ARMED FORCES RADIOBIOLOGY RESEARCH INSTITUTE
8901 WISCONSIN AVENUE
BETHESDA, MARYLAND 20889-5603

The Armed Forces Radiobiology Research Institute (AFRRI) reactor facility requests to amend the Technical Specifications for license R-84 (Docket 50-170) with the changes described in Enclosure 1. A change bar in the right margin shows proposed changes. These changes are necessary to comply with the new 10 CFR 50.59 as well as to provide for more efficient reactor operation. These changes are also in preparation for submittal of the reactor-relicensing package in 2003 and we request that they be reviewed using relicensing criteria. In reformatting the document, numerous lines of text moved to different pages. We are therefore resubmitting the entire document (at Enclosure 2) as proposed Amendment 24.

Technical Specifications
Summary of Proposed Changes

AFRRI REACTOR FACILITY

Figure 1. Organization of Personnel for Management and Operation of the AFRRI Reactor Facility

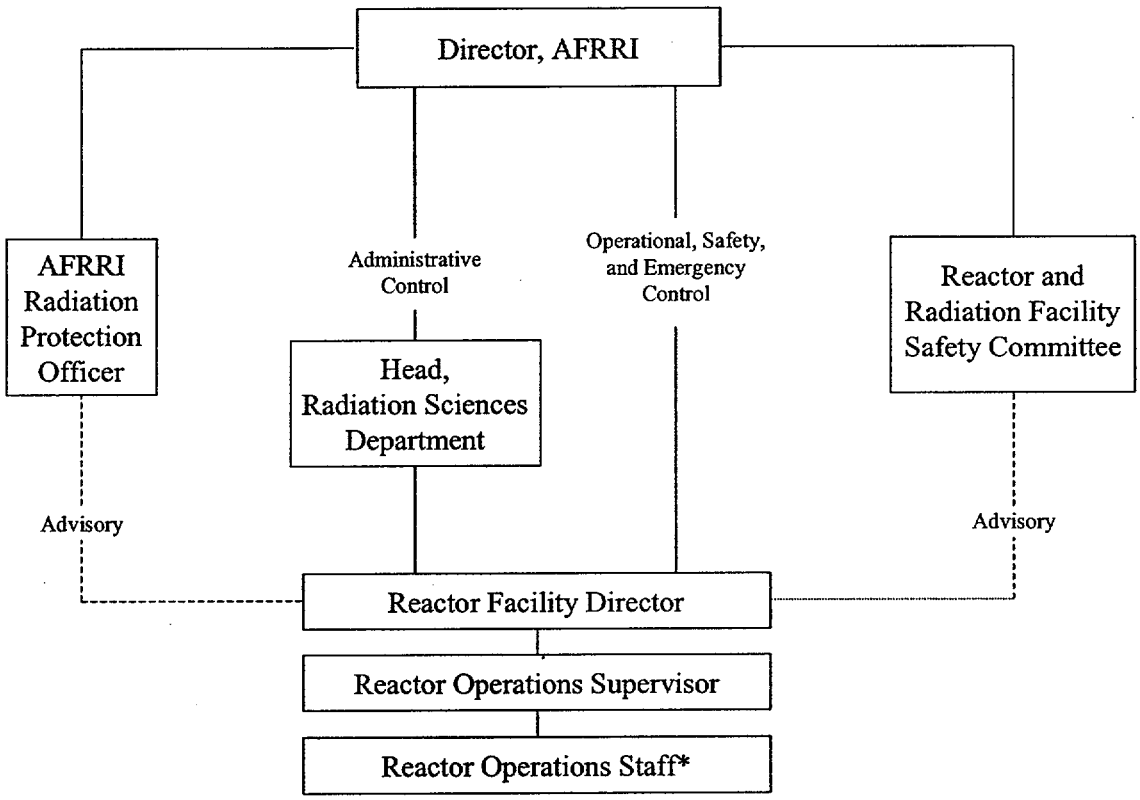
6. Section 6.1.1 - In the organization chart, change "Radiation Sources Department" to "Radiation Sciences Department" to conform to current AFRRI usage. This in no way affects reactor operation or safety.
